Name of Dam: Gaines Mill Dam

# PHASE I INSPECTION REPORT

Gaines Mill Dam (Inventory Number VA 08506)  
James River Basin, Hanover County, Virginia.  
Phase I Inspection Report.

BRIEF ASSESSMENT OF DAM

FIELD SKETCH  
GAINES MILL DAM

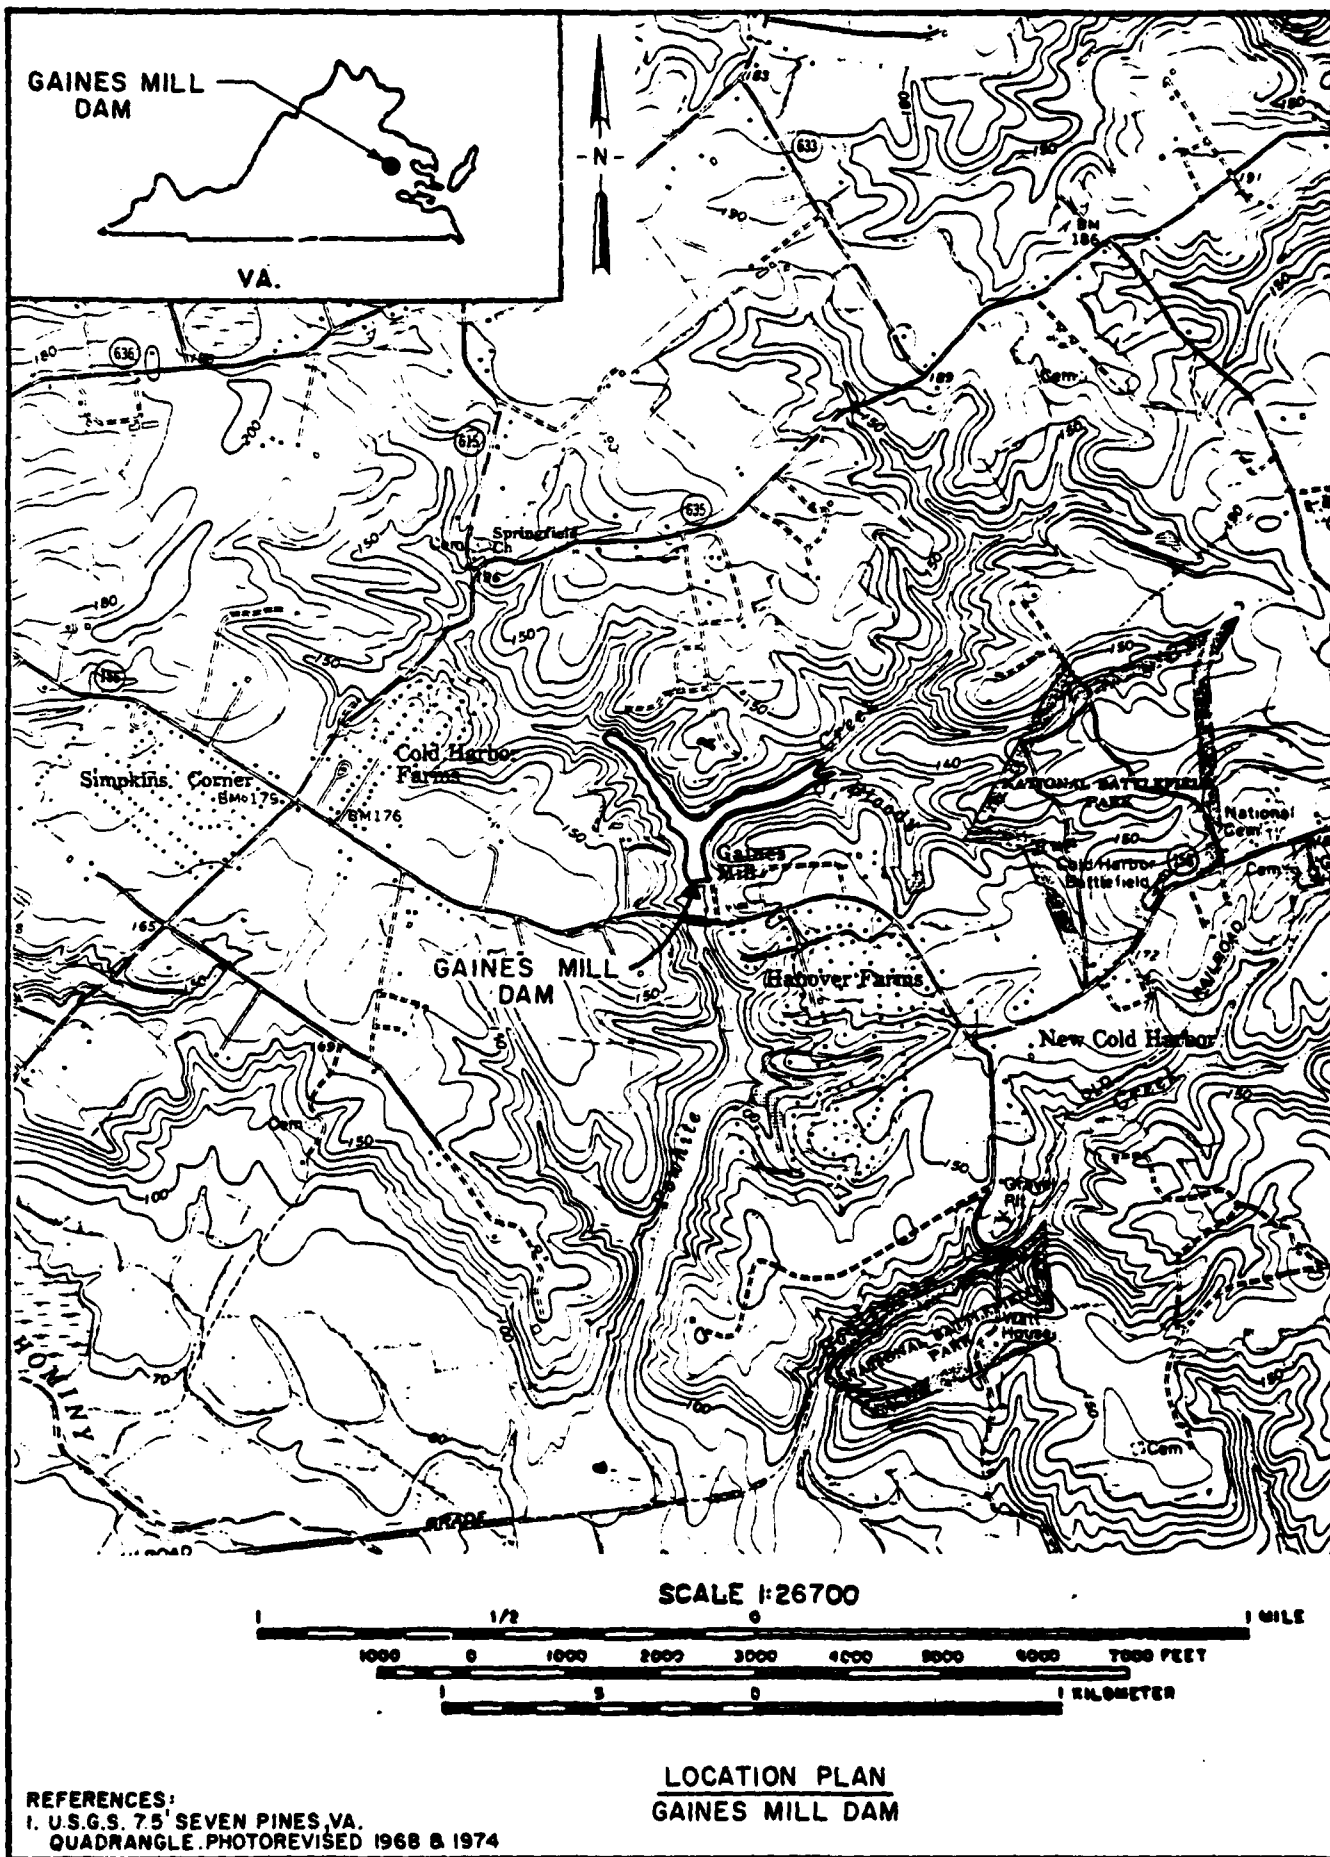
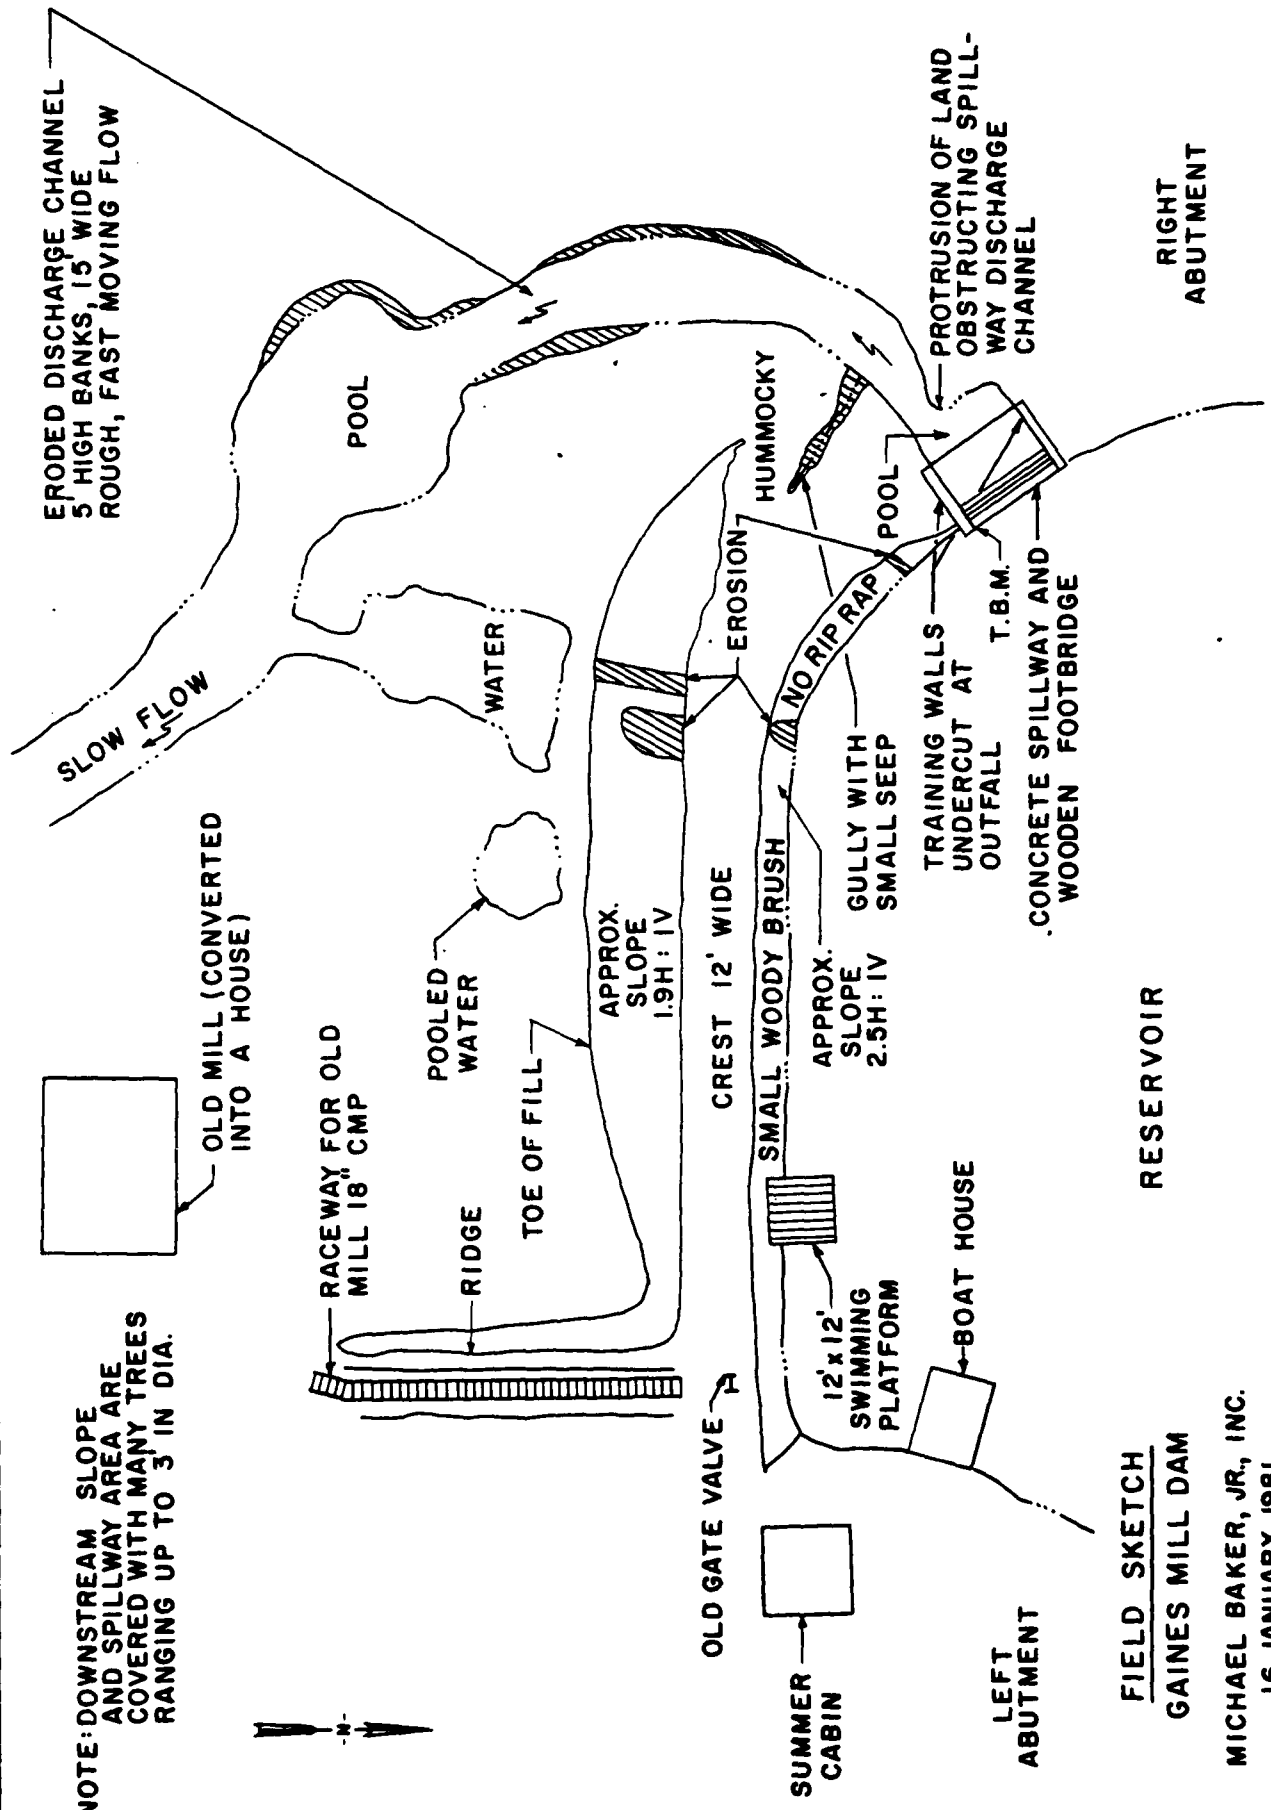
3.1.2 Dam: The embankment was found to be in generally fair condition. No surface cracks or unusual movement or cracking at or beyond the toe were observed. The downstream face of the dam is hummocky with slopes varying from 1.9H to 1.4H:1V. Sloughing and erosion are evident on the downstream slope near the right end of the dam. The upstream face of the dam is also hummocky with small brush present and evidence of slight wave erosion. An eroded area, approximately two feet wide and two feet long and sloping into the reservoir, was observed on the upstream face about 100 feet left of the spillway. A small gully, about 0.5 feet deep and extending from the crest to the reservoir, was observed on the upstream face about 10 feet left of the spillway. The crest of the dam has a straight horizontal alignment except for a slight designed curvature at the right abutment. The vertical alignment of the dam varies about 1.0 foot. Settlement of about one foot was observed along the left abutment where the 18-inch CMP crosses the dam. There

3.2 Evaluation: In general, the dam and appurtenant structures are in fair condition. Brush and trees should be removed from the embankment by cutting them off at ground level. Trees with a trunk diameter greater than 3 inches should also have their root systems removed. The resultant holes should then be backfilled, compacted and seeded. The low area in the crest near the left abutment is not considered to be significant enough at this time to warrant repairs. On the upstream embankment, areas of erosion should be backfilled, compacted and seeded. The seep in the gully on the downstream embankment is clear with no evidence of piping and is not considered serious. The gully, soggy areas near the toe, and the two large ponded areas at

- 1) Cut brush and trees on the embankment at ground level and remove the root systems of trees with a trunk diameter greater than 3 inches. The resultant holes should then be backfilled, compacted and seeded.

- 2) On the upstream face, backfill, compact, and seed the two eroded areas left of the spillway.
- 3) On the downstream face, backfill, compact, and seed the gully across the right side of the slope to the discharge channel, and the soggy areas and ponded areas near the toe of the embankment.
- 4) Repair the eroded concrete on the spillway retaining walls.
- 5) Clear the discharge channel of sediment, fallen trees and other debris.
- 6) Install a staff gage to monitor reservoir levels above normal pool.

PLATE 3

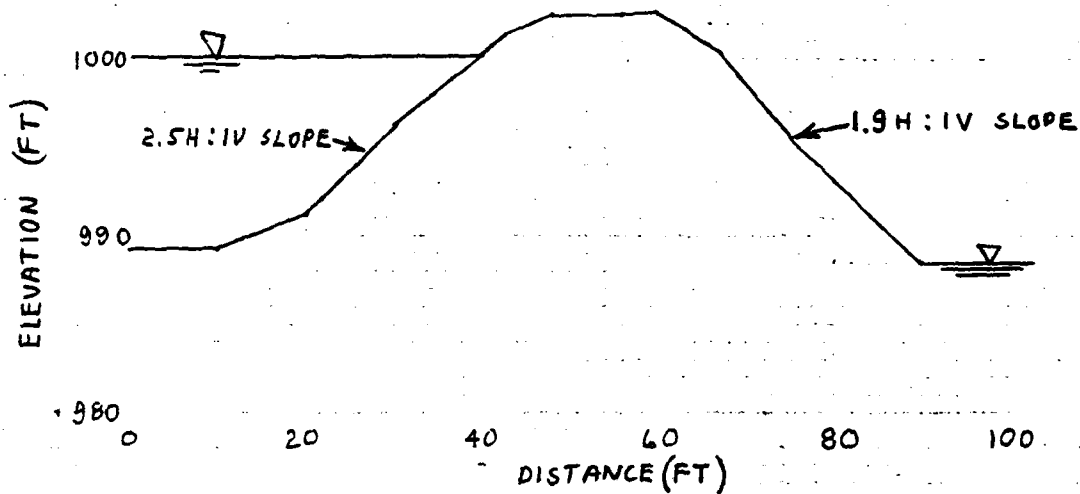
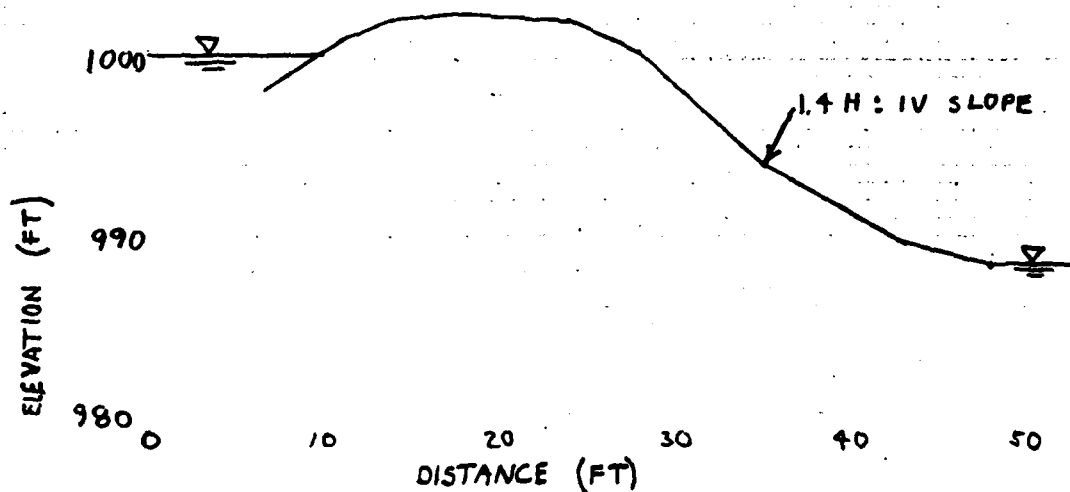
6.2.2 Stability: Design plans and the results of a previous stability analysis were not available for use during this evaluation. The embankment is assumed to be a homogeneous type. The dam is 14.2 feet high with a crest width of 12 feet. The upstream embankment was observed to slope about 2.5H:1V. The downstream slope ranged from 1.4H:1V to 1.9H:1V. No facilities exist for draining the reservoir in the event of an emergency, and the embankment is not subject to rapid drawdown. The embankment soils are considered to be of the CL or ML type (clay or silt of low to moderate plasticity) according to the USCS soil classification system.

slope of a small homogeneous dam constructed of CL or ML soils with a stable foundation should be 3.0H:1V if not subject to rapid drawdown. The recommended downstream slope is 2.5H:1V. A crest width of 13 feet is recommended, based on the height of the dam. Based on these guidelines, the crest width and embankment slopes are inadequate.

6.3 Evaluation: The results of a previous stability analysis were not available for review as part of this evaluation. The upstream and downstream slopes of the dam are steeper than recommended in the Bureau of Reclamation guidelines, and the crest width is slightly more narrow than recommended. However, signs of potential instability were absent during the visual inspection and a stability check is not required. Further attention should be given to the areas of possible seepage at the toe and the small clear seep at the
